POLICE ACADEMY
HILLA, IRAQ

SIGIR PA-05-032
JANUARY 31, 2006

SUBJECT: Report on Project Assessment of the Police Academy, Hilla, Iraq
(Report Number SIGIR-PA-05-032)

Police Academy in Hilla, Iraq

Site Photo 7. Crack in Hallway Wall in Instructor Billeting Area (Photo courtesy of Contracting Officer Representative; taken on 9 December 2005)

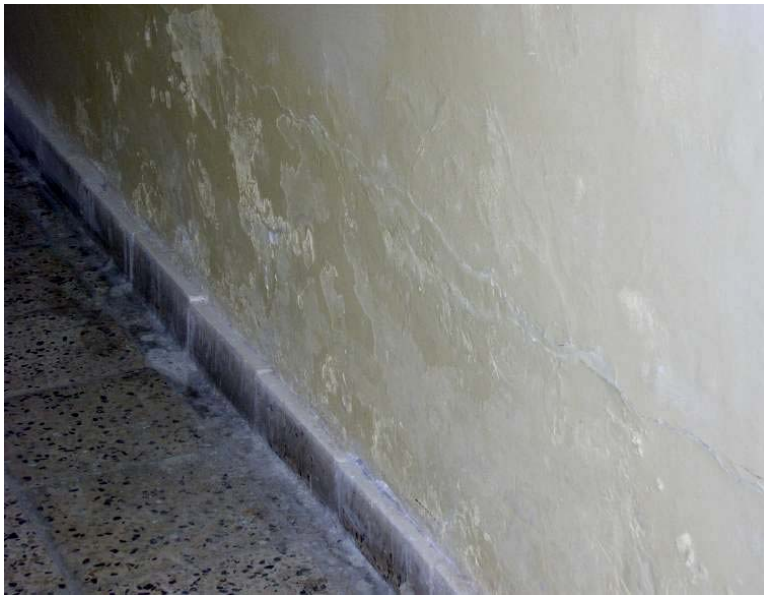
There were settlement cracks in the walls (Site Photo 7) at several locations within the building. We also noticed moisture damage along the hallway walls outside the bathrooms (Site Photo 8). The Contracting Officer in the Cure Notice to SBIG dated 22 May 2005 had noted these discrepancies.

Site Photo 12. Grinder Pump Basin with Close-up of Pump

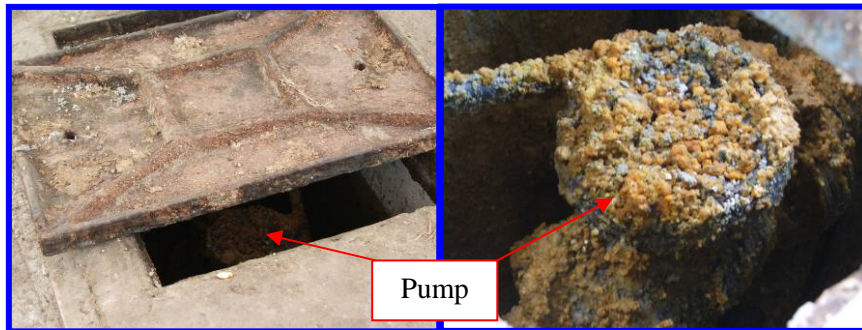
DABV01-04-M-8070: The wastewater facility did function as the contract required. The contractor did not resolve the design, capacity, and operation issues. Although, the system was designed to operate with two pumps, only one pump was installed.

The contract originally called for a wastewater lift station with a grinder pump (and a backup pump) capable of transferring effluent 500 linear feet from the camp to the nearest city sanitary sewer manhole; our assessment showed one pump. The wastewater

is not pumped to a city sanitary sewer manhole but it is pumped to wastewater collection tanks on site where it is stored until collected by vacuum trucks. Site Photo 12 shows the grinder pump basin and a close-up of the pump. The pump is entirely encrusted with deleterious material deposits which indicate no preventive maintenance was performed.

Site Photo 16: 220 KW Generator at Hilla Police Academy

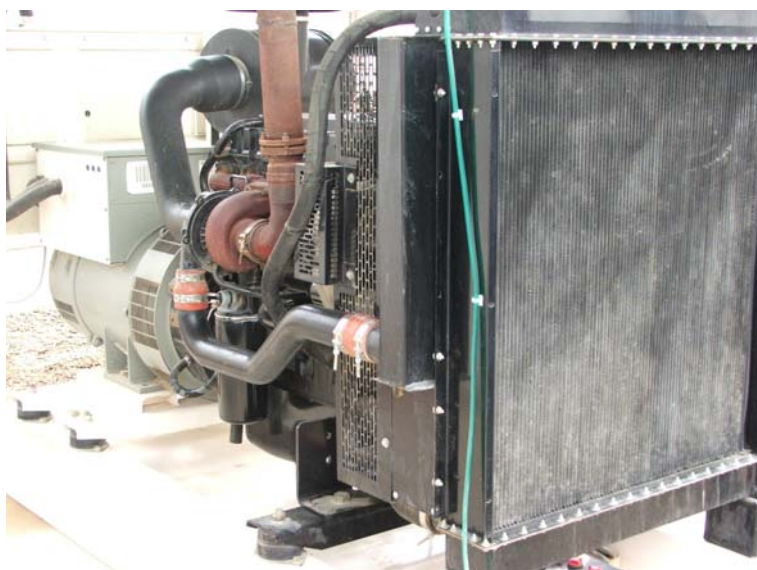
The other generator onsite, shown in Site Photo 16, is rated at 220 kilowatts. While on site, an employee of the current life support contractor, SBIG, started the engines on both generators and let them run for several minutes. However, the generators did not carry any electrical load during the test runs. The police academy currently relies on commercial power as its primary source of electricity, with the generators serving as a backup. At this time, it could not be determined how much of the electrical demand from the police academy could be supported with power supplied solely from the two generators.
